**PRELIMINARY DRAINAGE REPORT**

**THE RETREAT AT TIMBERRIDGE  
PRELIMINARY PLAN  
(SOUTH OF ARROYA LANE)**

619 N. Cascade Avenue, Suite 200 Colorado Springs, Colorado 80903 (719)785-0790 (719)785-0799 (Fax)	<b>THE RETREAT AT TIMBERIDGE</b> PRELIMINARY DRAINAGE REPORT (SOUTH OF ARROYA LANE) PRE-DEVELOPMENT DRAINAGE MAP				
	DESIGNED BY	MAW		SCALE	DATE
	DRAWN BY	MAW		(H) 1" = 200'	SHEET 1 OF 2
	CHECKED BY	(V) 1" = N/A		JOB NO.	2520.00

## Box Culvert *(Arroya Lane & prop. collector Rd.)*

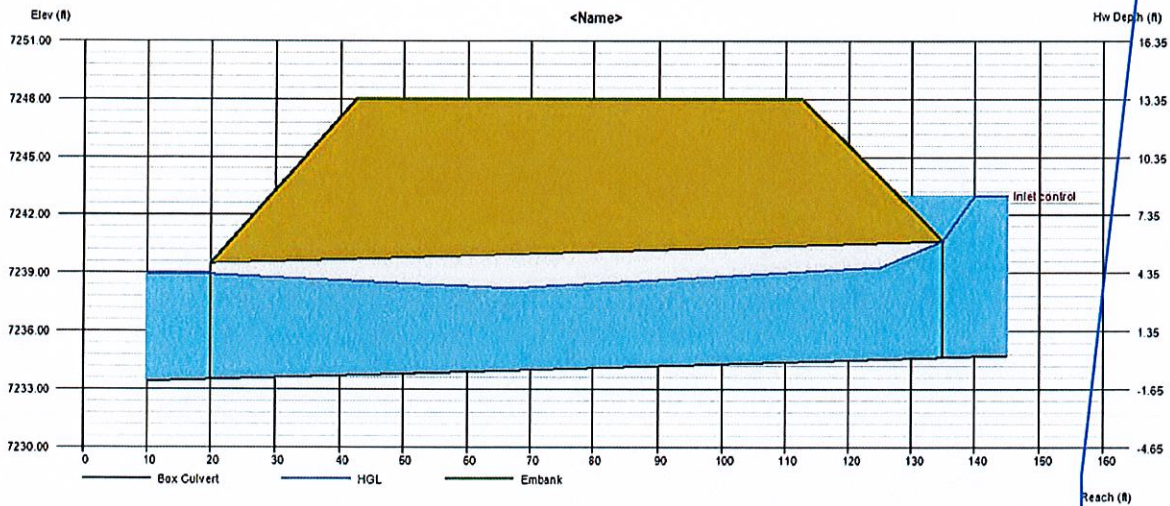
This needs to be for FEMA flows unless there is a LOMR reducing the flows. Provide for both.

**DESIGN POINTS SURFACE ROUTING SUMMARY - EXISTING CONDITIONS**

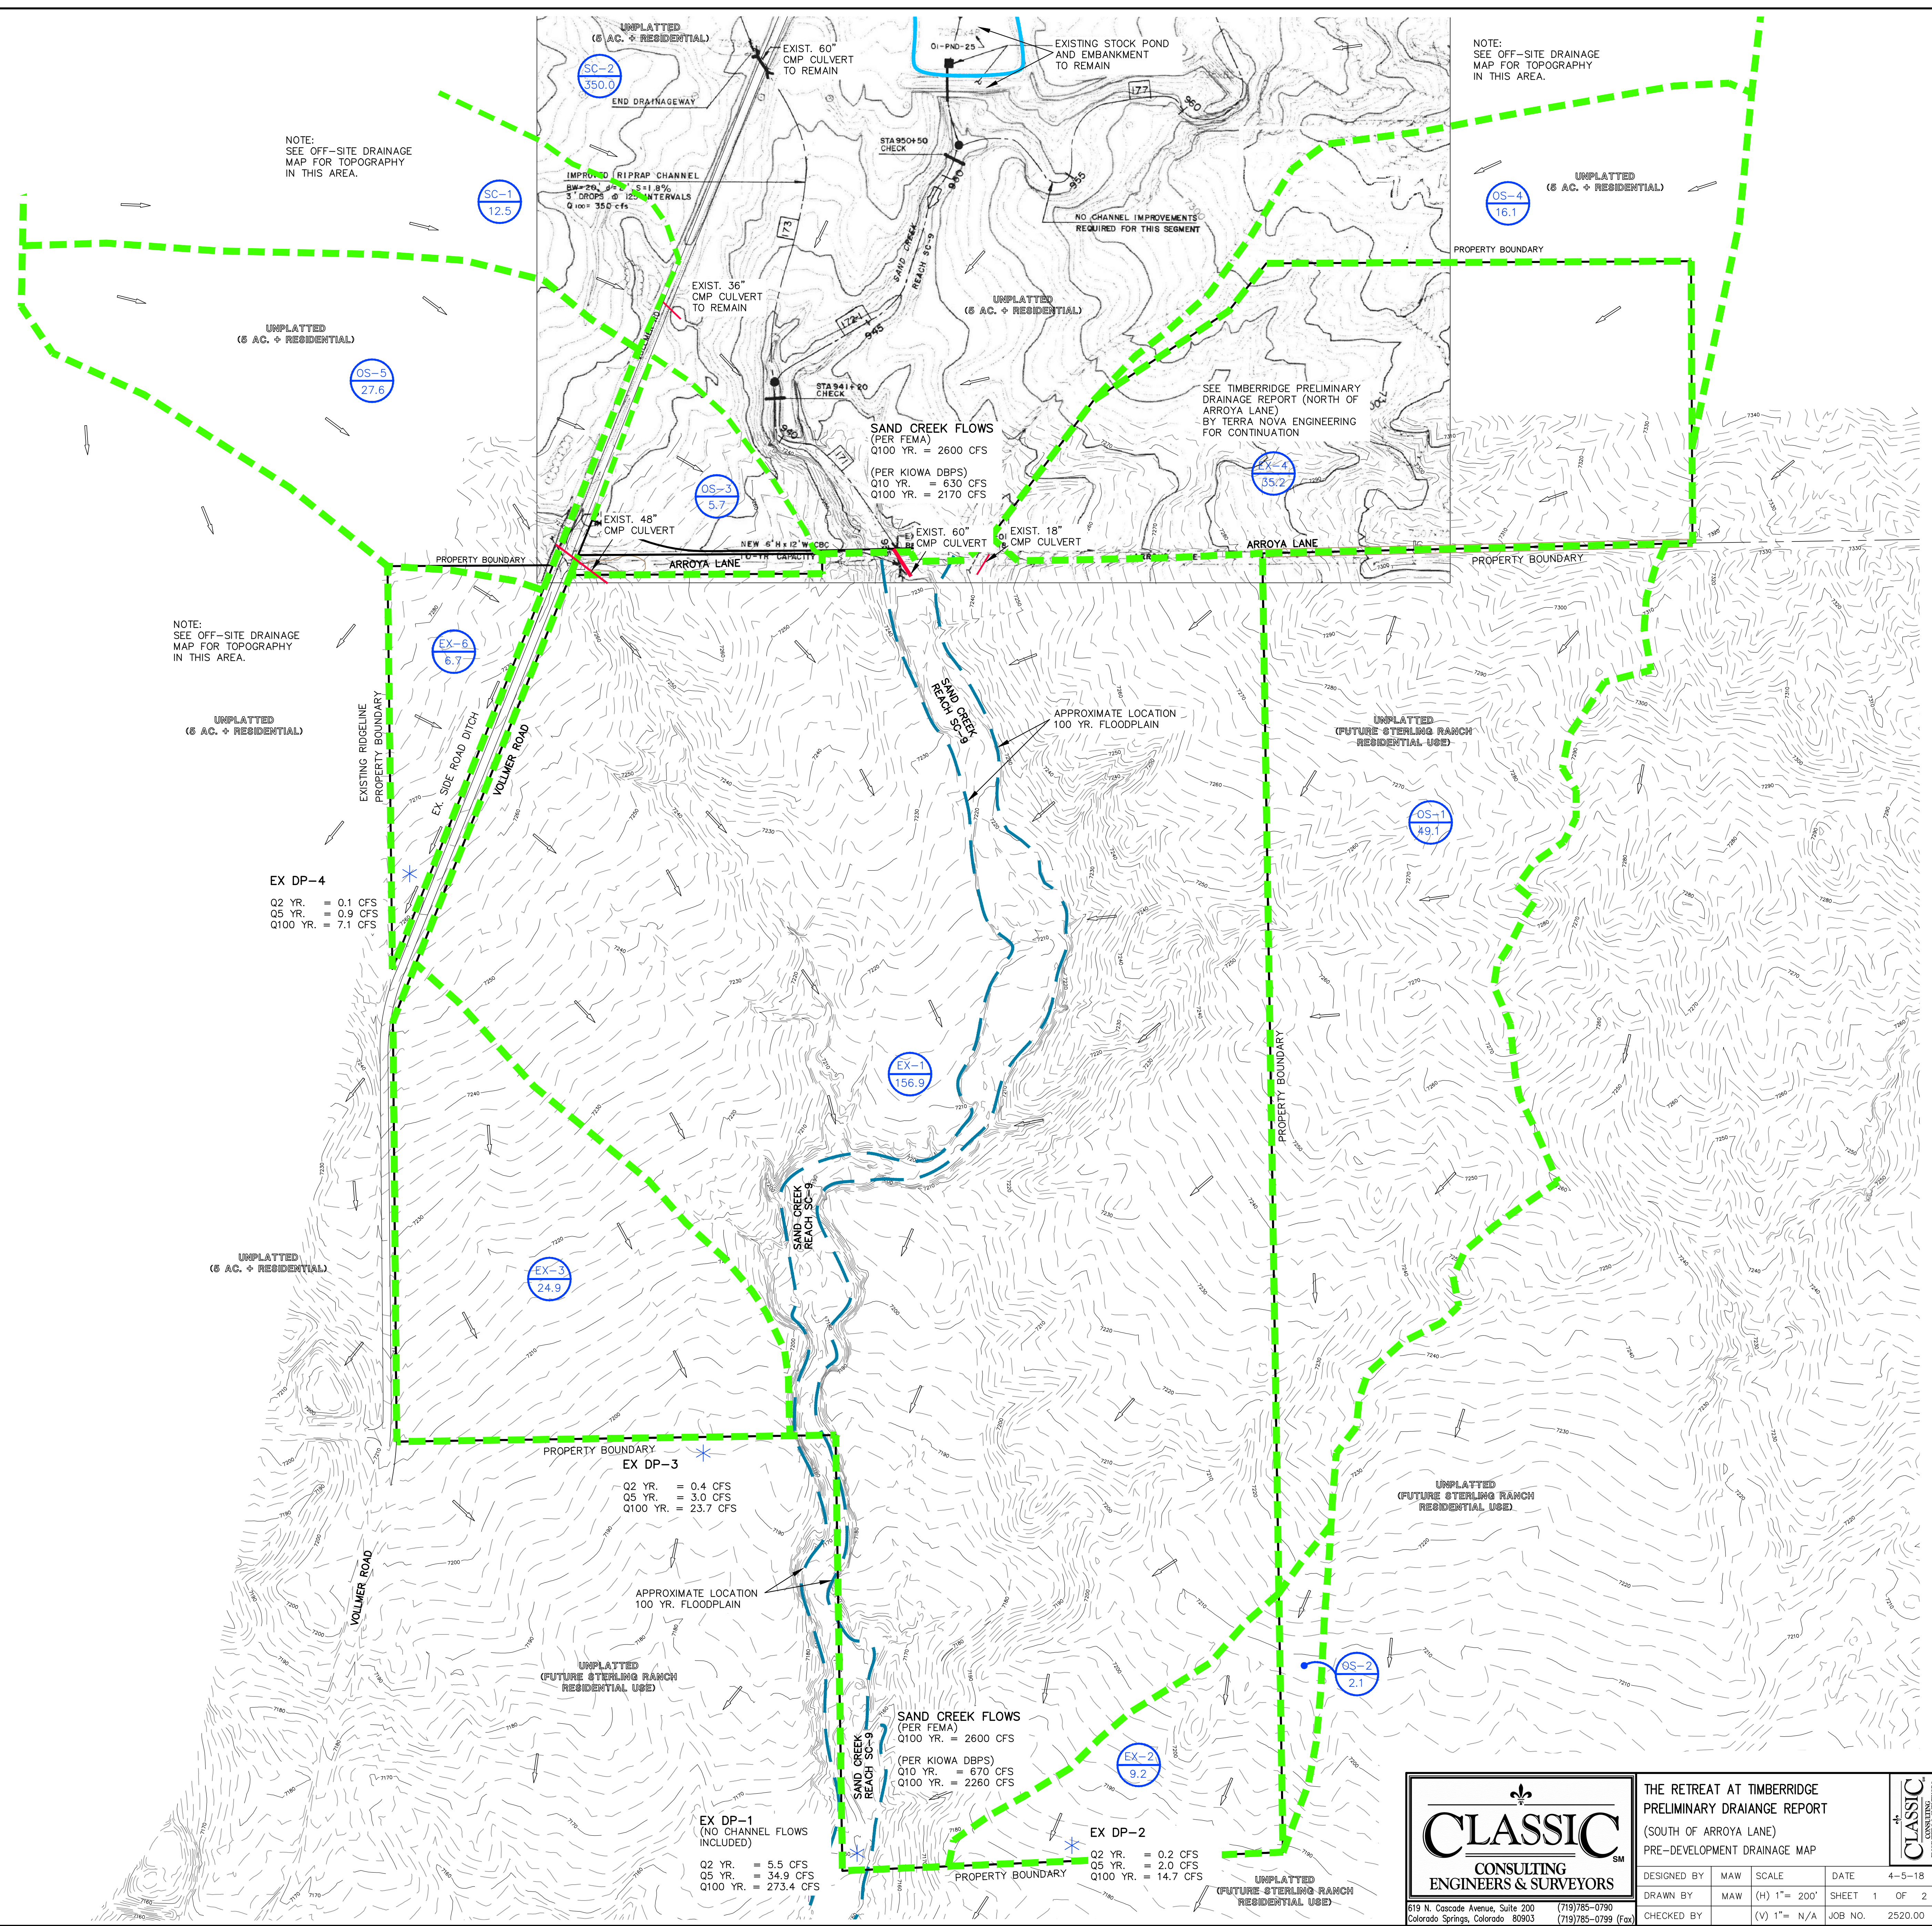
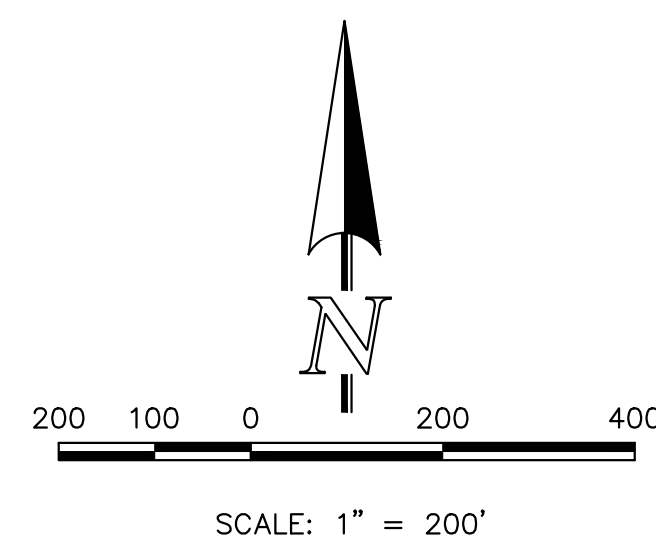
Delete?

Provide column with design point contributing area
